City of Albuquerque

RE: Grading and Drainage Plan for ENVIRCO (MCT Industrial Park) (B18/D4) Submitted for Building Permit Approval, Engineer's Stamp Dated 11/16/99.

ENVIRCO
GRADING AND DRAINAGE PLAN
MARK GOODWIN & ASSOCIATES, P.A.
CONSULTING ENGINEERS
P.O. BOX 90606
ALBUQUERQUE, NEW MEXICO 87199
(505)828-2200, FAX (505)797-9539

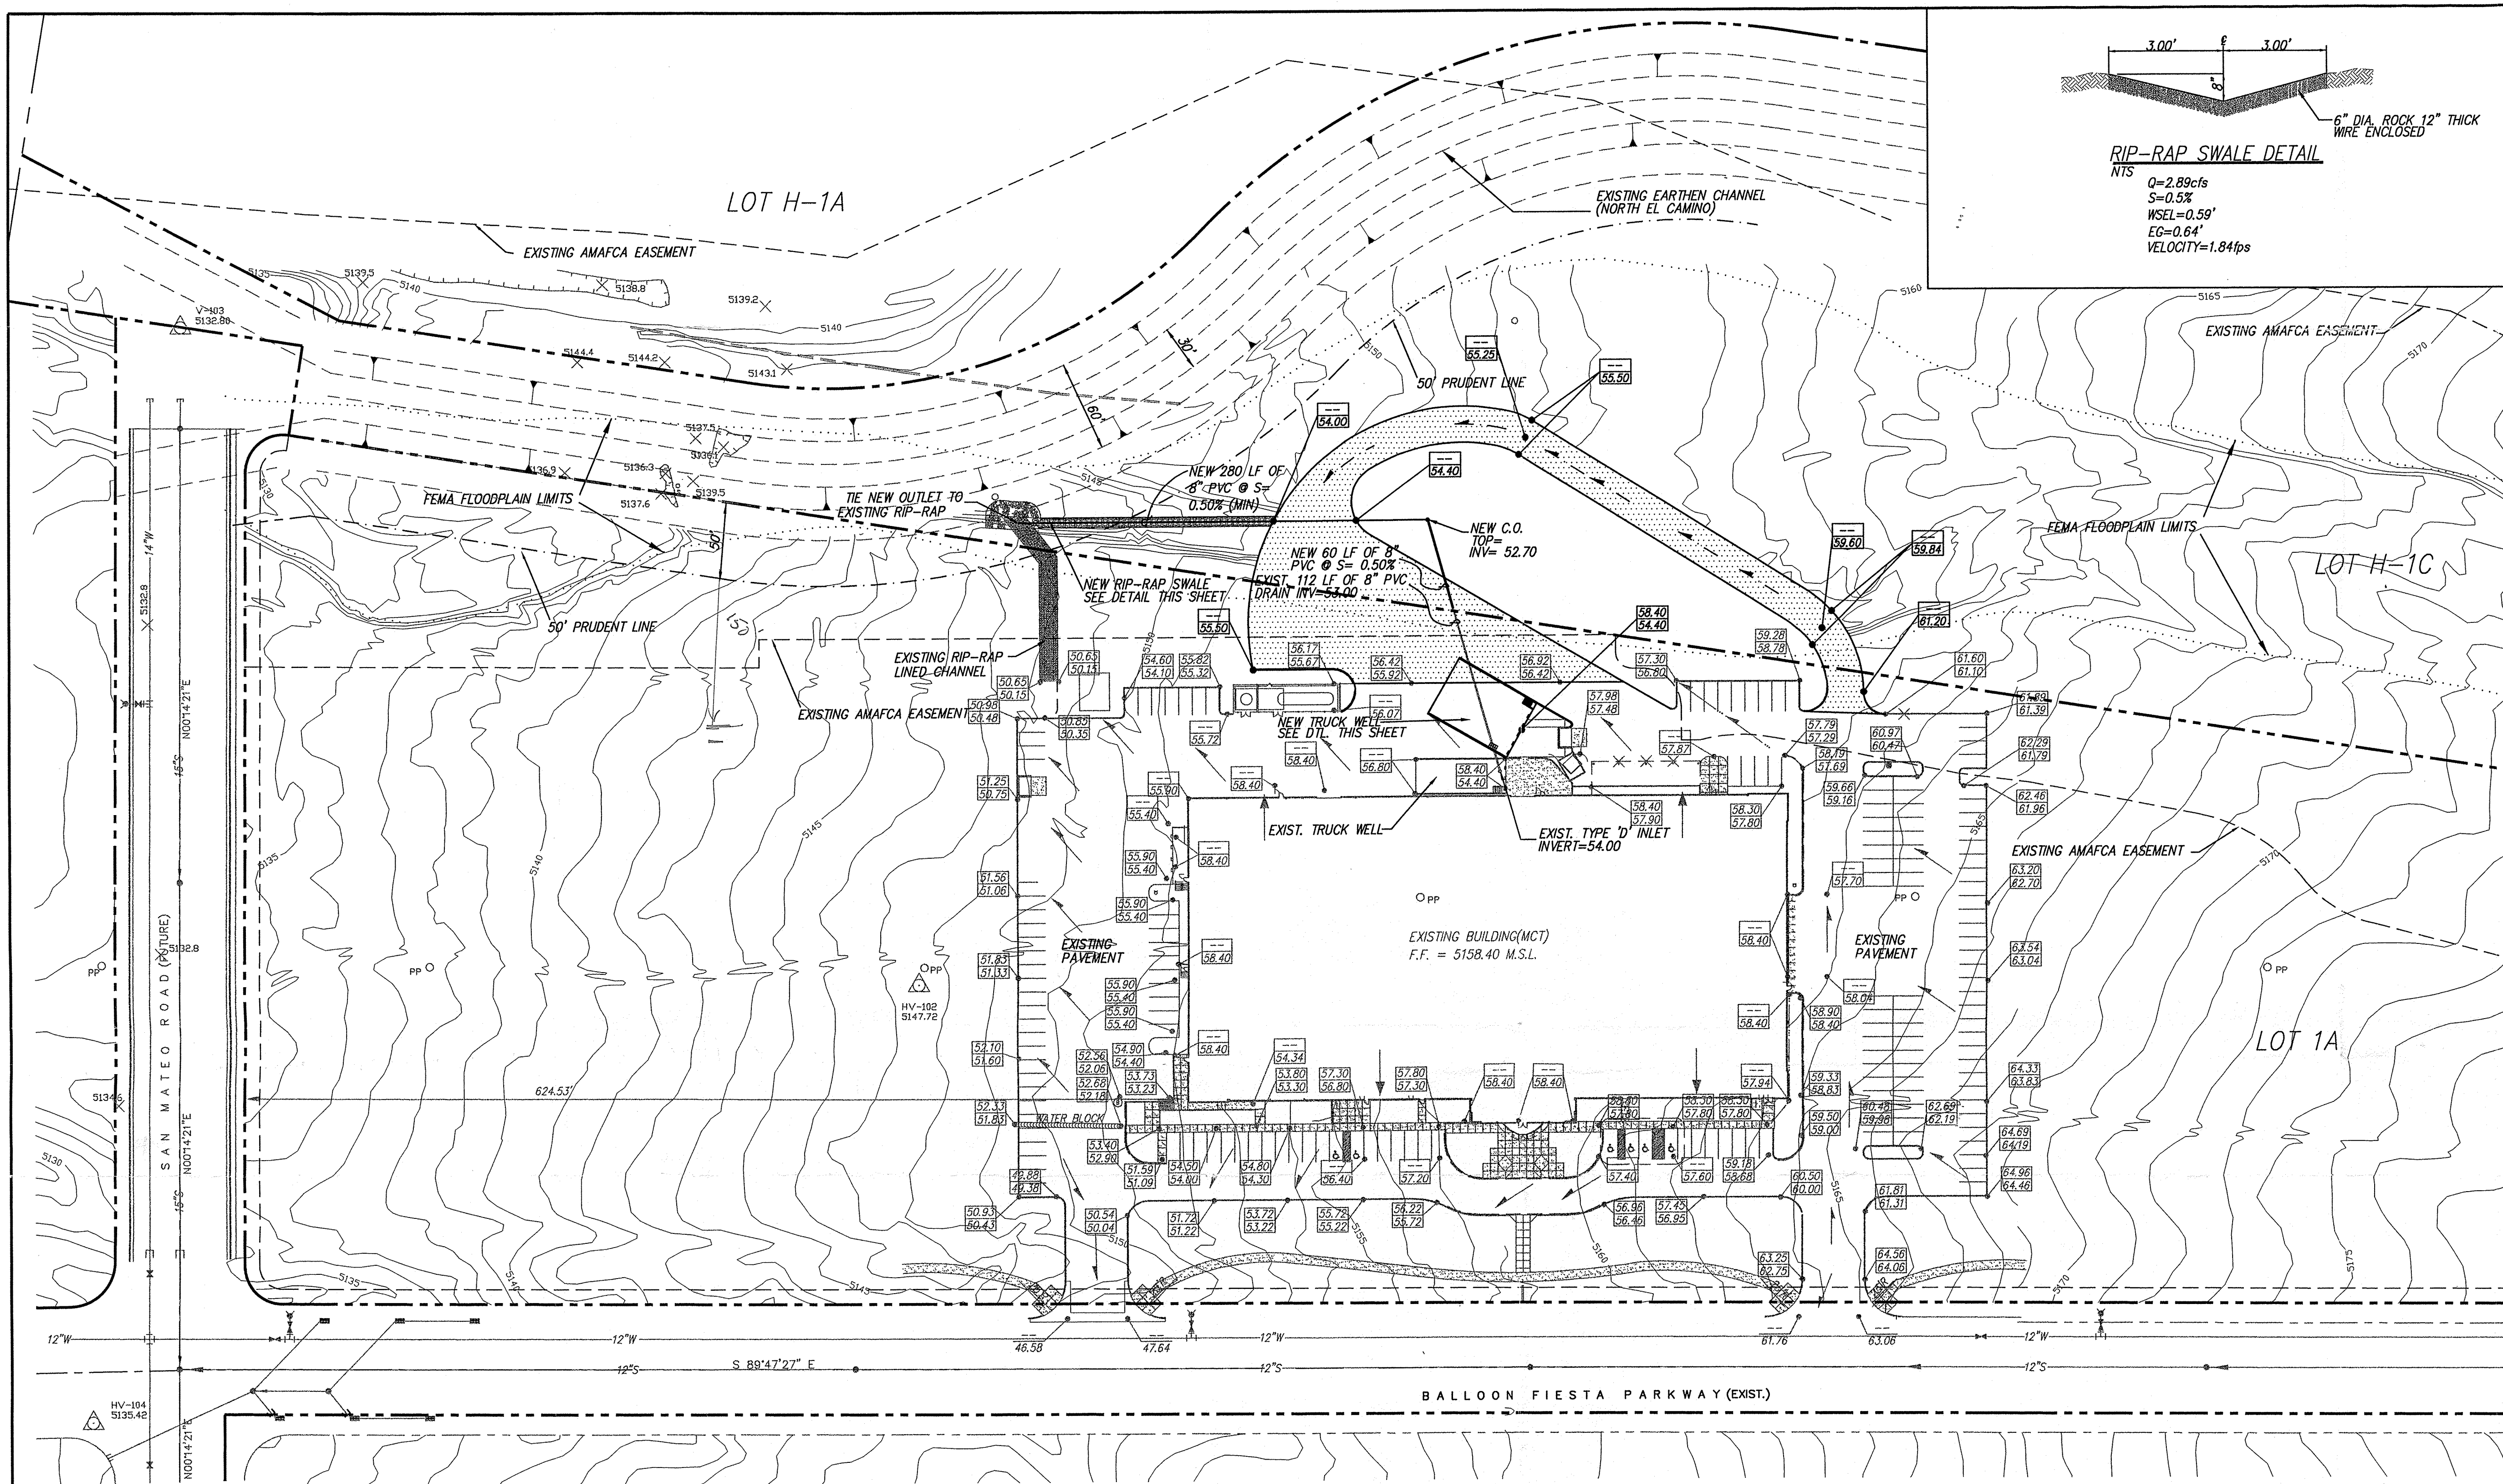
The above referenced plan proposes to use 2 feet per 100 cfs as the erosion setback limit (ESB). Although AMAFCA has no problem with this concept, the City requires that the ESB be estimated using 6 feet per 100 cfs, or calculated using the methods in AMAFCA's Sediment and Erosion Design Guide. It appears that no justification for a variance for this requirement has been provided.

The City does not allow any hard improvements, including paving, within the ESB without erosion protection. Please revise the ESB on the plan and show the erosion protection for the proposed improvements.
